SERVICE MANUAL

MODEL
TC1966D

REVISION
SUFFIX C

COLOR TELEVISION RECEIVER

For interchangeability (TRANSISTOR)

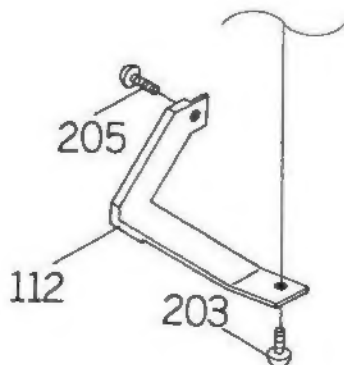
REF. NO	SUFFIX B		SUFFIX A, C	
	PART NO	DESCRIPTION	PART NO	DESCRIPTION
△Q351	TC30039020	TRANSISTOR 2SC3902(S, I)	TC30041590	TRANSISTOR 2SC4159(D, E)
△Q352	TC30039020	TRANSISTOR 2SC3902(S, I)	TC30041590	TRANSISTOR 2SC4159(D, E)
PCB001	A39709A01BZ1	MAIN PCB ASS'Y	SEE ABOVE	MAIN PCB ASS'Y
